SUBJECT: Request Council Authorization to Convert Wickliffe Street to One-Way

SUBJECT: Wickliffe Street One-Way Request

BOARD OF ADJUSTMENT STAFF CASE REPORT

V-2015-66; URBAN 221, LLC - appeals for variances to reduce the required front yard from 10 feet to 0 feet and to reduce the ground level open space requirement from 2% to 0% in a Downtown Frame Business (B-2A) zone, at 211 & 221 Corral Street; 166, 170, 174, 178 & 180 N. Martin Luther King; 212, 214, 216, 218 & 220 Wickliffe Street & the former Barkley Street right-of-way (Council District 1).

Wickliffe St
Lexington, Kentucky

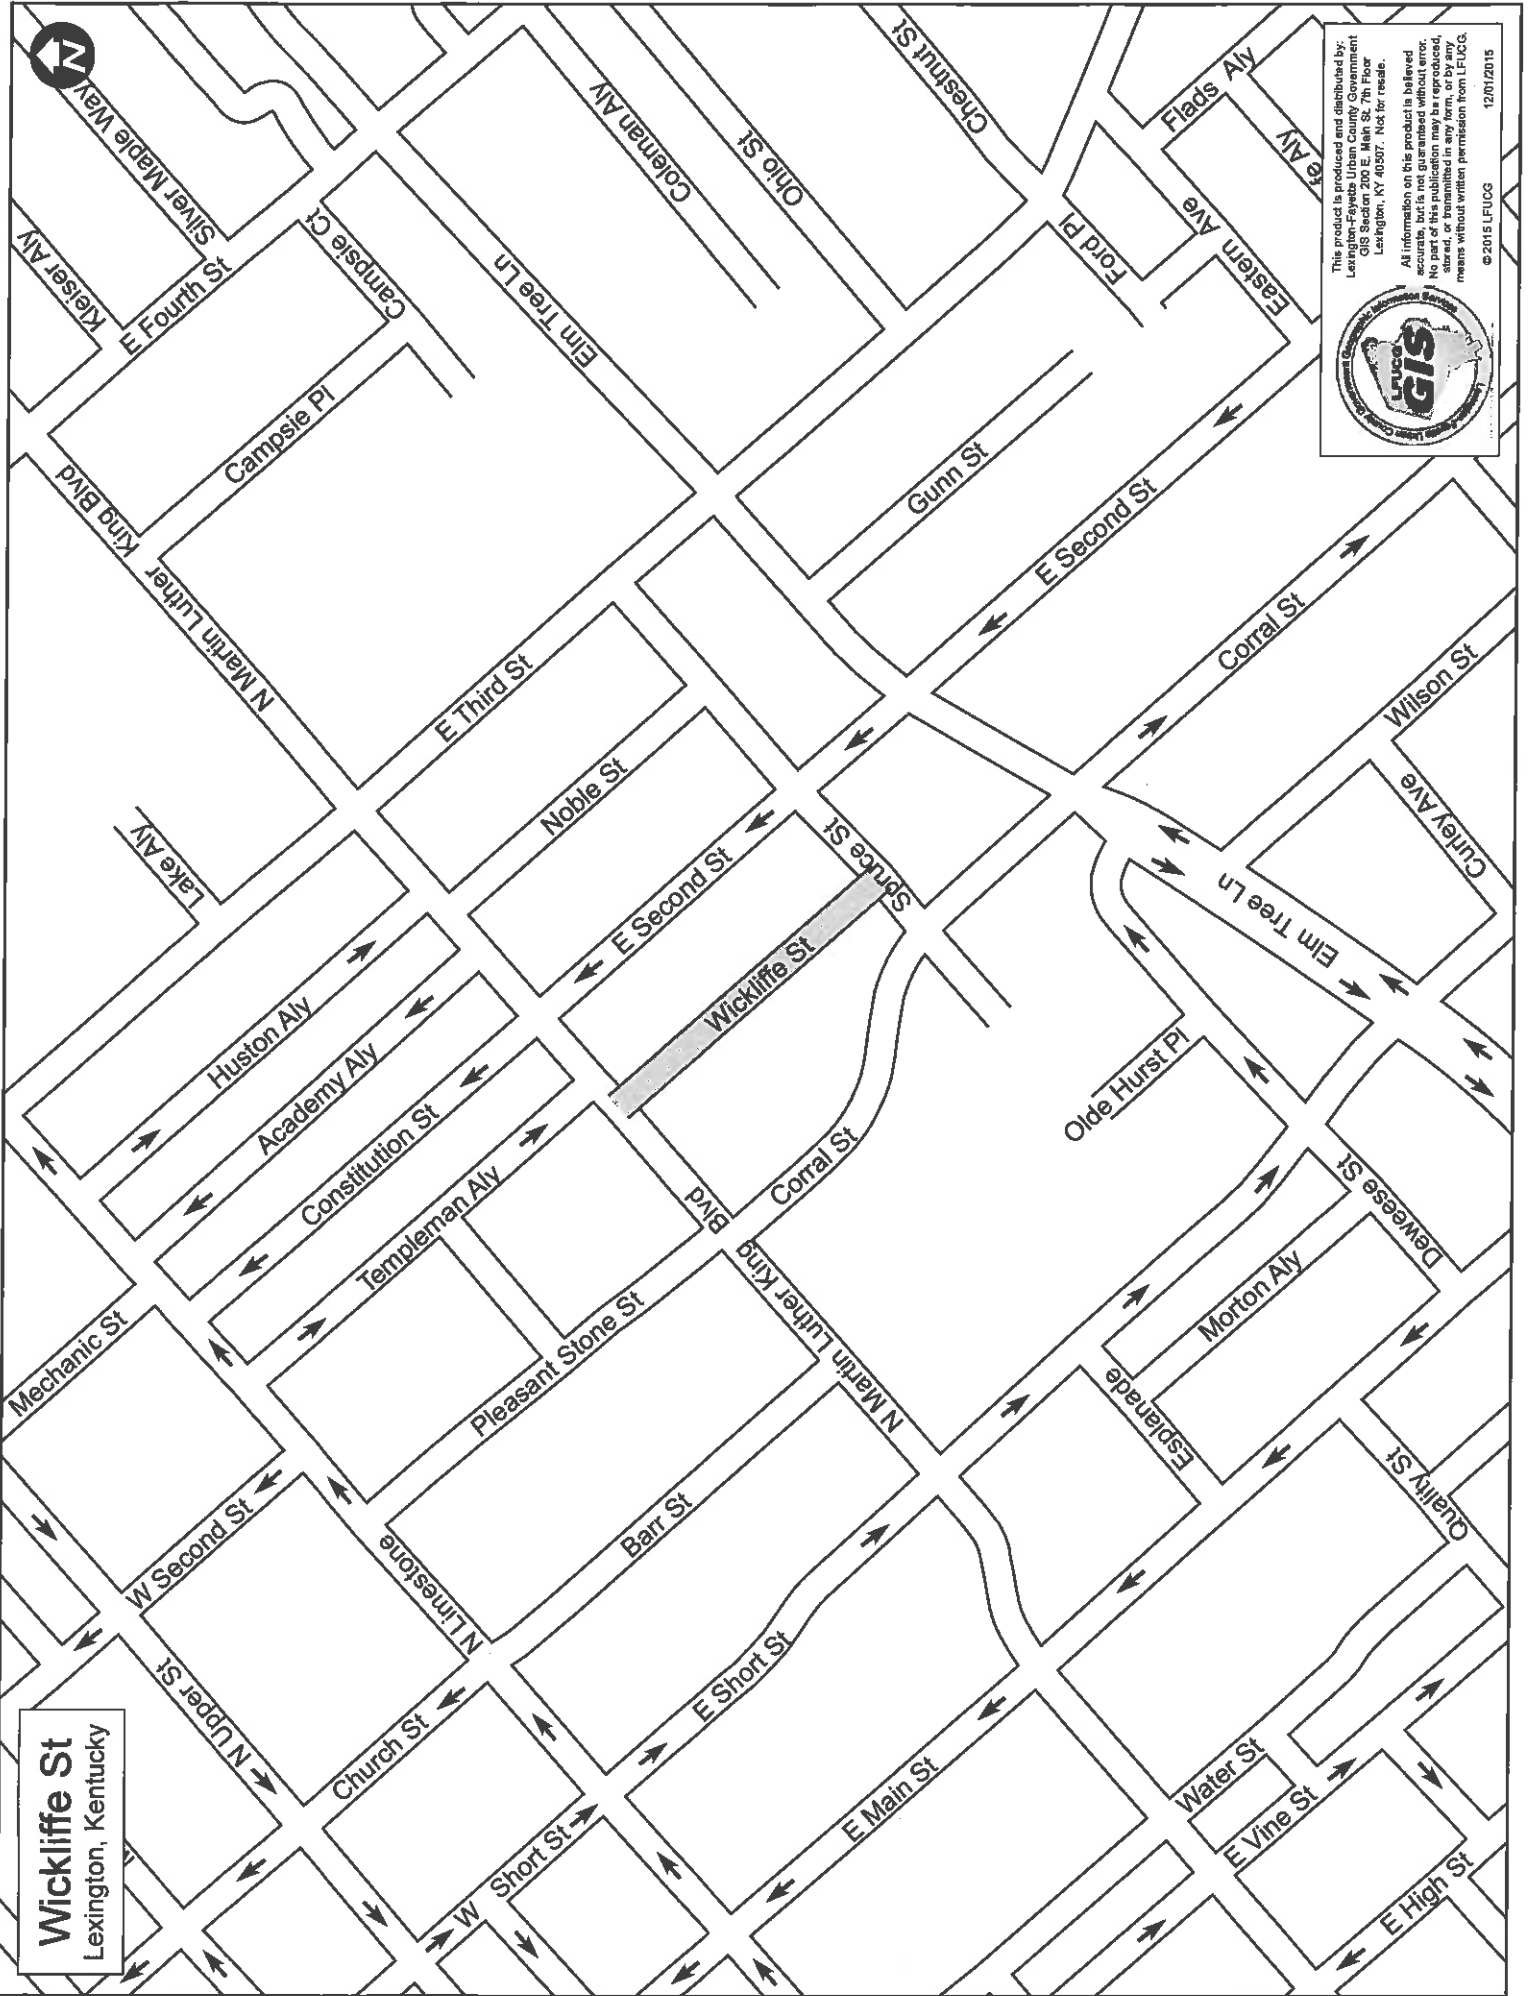
Traffic Engineering staff has reviewed the request from Urban 221, LLC to convert vehicular travel on Wickliffe Street from two-way to one-way operations. Wickliffe Street is located between North Martin Luther King Blvd and Spruce Street. The proposal is to designate one-way travel from west to east (or from MLK to Spruce St.).

Wickliffe Street is approximately 550 feet long and 16 feet wide. Although it is classified as a local street, it currently functions as an alley to serve the adjacent property owners. Due to limited width, it is not safe for two-way operations. Additionally, due to the short length of the street, conversion to one-way does not negatively impact traffic patterns in the area.

Traffic Engineering does not oppose the request convert Wickliffe Street to one-way operations.

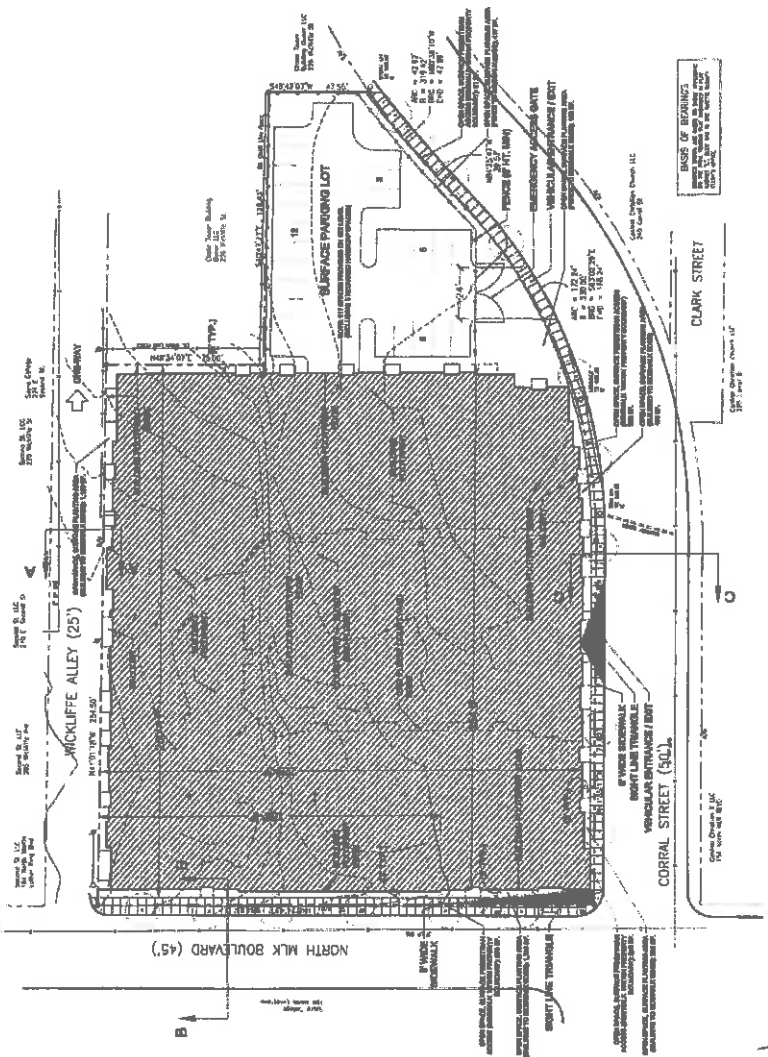
Although the variance requested is the same for each of the three street frontages, after reviewing the application with the Bike and Pedestrian Planner, the recommended sidewalk widths will be different on each of these three streets, frontages; therefore, staff is recommending (through the conditions of approval) a different setback for each street. In general, staff is supportive of a 0' setback for the 2nd story and above, provided there will pedestrian-friendly accommodations made on

the first floor and that at no point will the building be in any regulatory sight triangle. The provision of an inviting pedestrian experience along the ground floor is fundamental to the staff's recommendation of approval of the requested variances. A 4'- wide sidewalk is completely inadequate for pedestrian safety and comfort when the building is less than 10' from the street right-of-way.

The most prominent street frontage is North Martin Luther King Boulevard. It is recommended that on this street, the minimum pedestrian sidewalk width be 8' and that the buildings be designed to be located outside of all the required sight triangles. At the second story and above, the setback should be allowed at the right-of-way. Furthermore, it is recommended that architectural details, in combination with landscaping or other similar treatment, be developed along this frontage in order to encourage a safe and inviting pedestrian experience along this major corridor. Instead of requiring a specific detailed design at this time, it is recommended that the Design Excellence Officer review and sign off on the final designs proposed by the applicant's architect prior to construction.

Corral Street has a similar recommendation, with a pedestrian sidewalk width of 6'. The recommendations related to sight triangles and design details on N. Martin Luther King should also apply to Corral Street, which will serve as the primary entrance for the apartment building.

Wickliffe Avenue is different than the other two streets; it is best described as either a narrow street or a wide alley. Although considered a public street, it functions similarly to an alley, primarily providing frontage to the rear of lots facing E. Second Street. The applicant proposes that this street would best serve the community if it were to become a one-way alley, leading away from N. Martin Luther King toward Spruce Street. Although staff agrees that the proposed street configuration has merit, it will require action by the Urban County Council to make these changes to the street system.

The status of Wickliffe Avenue, especially the one-way provision, has a major impact on the review of the requested setback variance along this street. Provided that the Council agrees and changes the street system, the requested variance is appropriate and will not have an adverse impact on the subject or surrounding properties. If they do not agree, and the street is to remain as a two-way street, not only does that bring into question the appropriateness of the requested variance, but also whether or not street widening and other street improvements should be required as a part of this project. Along this frontage, and at the corner of N. Martin Luther King Boulevard and Wickliffe Avenue, staff recommends a provisional approval of the requested setback variance. It should also be noted that the Planning Commission may require improvements to Wickliffe Avenue as a part of the development plan approval, in which case the variance recommendation for this street frontage would also be affected.

3. The setback variance along N. Martin Luther King Boulevard shall be to 0' for the second story and above. The ground floor variance will be to the minimum necessary to provide an 8' wide pedestrian sidewalk (including any combination of architectural details and landscaping or other design elements as agreed to by the Bike and Pedestrian Planner and the Design Excellence Officer in the Division of Planning), in order to create a safe and inviting pedestrian walkway. At no point shall the building be allowed in any required sight triangles.

4. The setback variance along Corral Street shall be to 0' for the second story and above. The ground floor variance will be to the minimum necessary to provide a 6' wide pedestrian sidewalk (including any combination of architectural details and landscaping or other design elements as agreed to by the Bike and Pedestrian Planner and the Design Excellence Officer in the Division of Planning) in order to create a safe and inviting pedestrian walkway. At no point shall the building be allowed in any required sight triangles, including those at the entrance/exit to the parking garage.

5. Provided the Urban County Council allows Wickliffe Avenue to become a one-way alley, the setback from the right-of-way may be reduced to 0'. Should the Urban County Council not change the status of Wickliffe Avenue to a one-way alley, any variance request along this street frontage, and including the necessary setbacks for a sight triangle at the intersection of Wickliffe Avenue and N. Martin Luther King Boulevard, shall be considered null & void.
